GULF STATES UTILITIES COMPANY

River Bend Station-Unit 1
Docket No. 50-458

RESPONSES TO NRC'S
REQUESTS FOR ADDITIONAL INFORMATION
OF JULY 23, 1985

RESPONSES TO INFORMAL

TEST PROFILE DATA FOR 247.501 BDDF 6247.501-240-002B

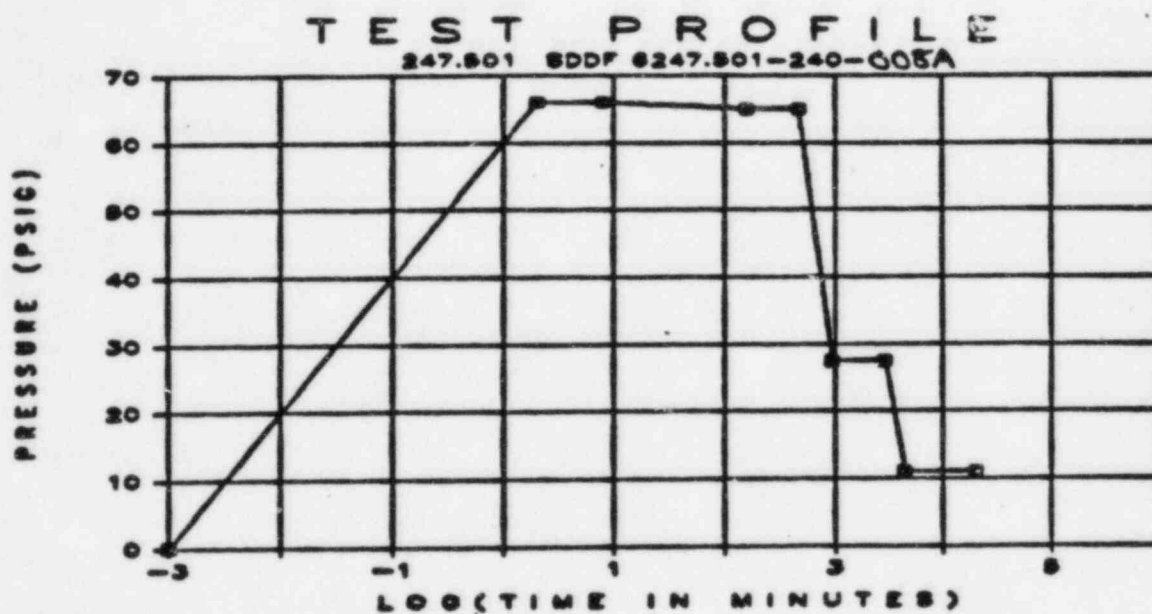
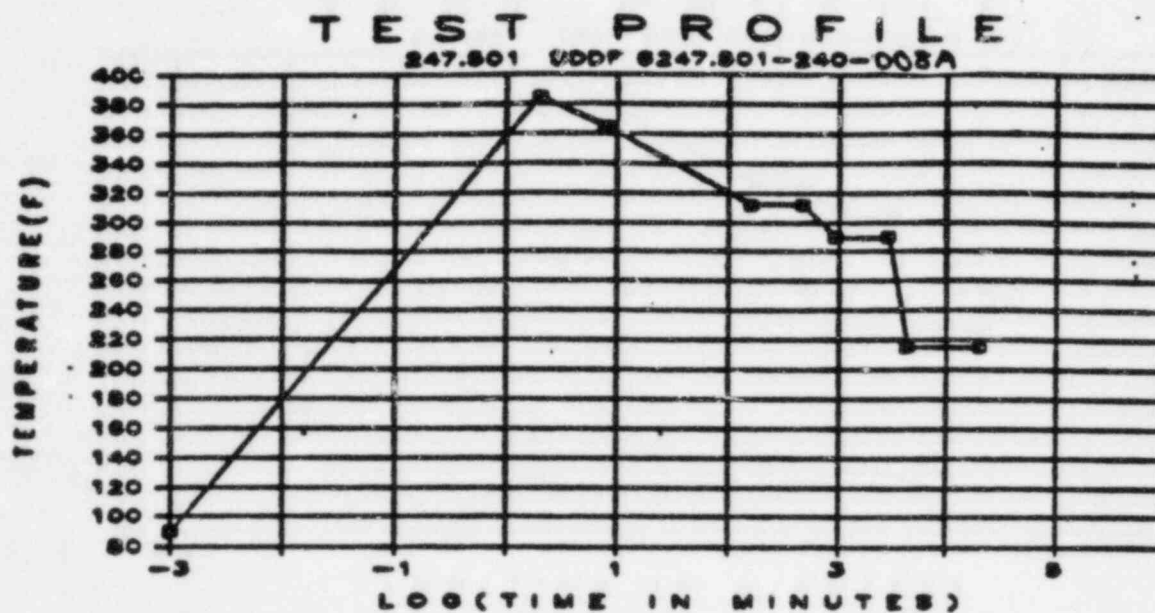
1. In your submittal, you state that a piece of equipment will survive if the maximum external surface temperature or the maximum internal temperature at the most limiting component reached during a hydrogen burn, is below the qualification temperature for this piece of equipment. During the qualification tests, the actual temperatures reached by the components of the tested equipment were not measured. Hence, you should demonstrate that the temperatures reached by the most limiting internal component of the equipment exposed to a hydrogen burn, remain below the temperatures reached by the corresponding components during the qualification tests (even though in these tests the equipment may be exposed to different temperature-time profiles).

As stated in the "River Bend Station Preliminary Equipment Survivability Report" submitted on July 1, 1985, the survivability of essential equipment is ensured if the surface temperature of the equipment remains below the qualification temperature. Only in the event that the outer surface temperature exceeds the equipment qualification temperature is it necessary to establish the temperature of the thermally limiting internal component. In our preliminary equipment survivability this additional step was only necessary to establish survivability of the Target Rock solenoid. The GSU analysis determined that the surface temperature of the solenoid when exposed to the hydrogen deflagration burn environment exceeded the qualification temperature (385°F) by 3°F. The corresponding temperature reached by the thermally sensitive component was 222°F. Since this was below the qualification temperature of the component the solenoid was judged to survive the hydrogen burns.

Validation of this approach by applying the equipment qualification temperature profiles to our equipment models has not been performed. This might be a useful procedure for the final equipment survivability analysis but was not considered necessary for a preliminary analysis. Inspection of the equipment qualification temperature profile (attached) for the Target Rock solenoid lends credence to the current methodology. The test profile for the target Rock solenoid indicates that the test temperature was in excess of 311°F for 8 hours. This extended soak time assures that the sensitive component can survive the predicted temperature of 212°F.
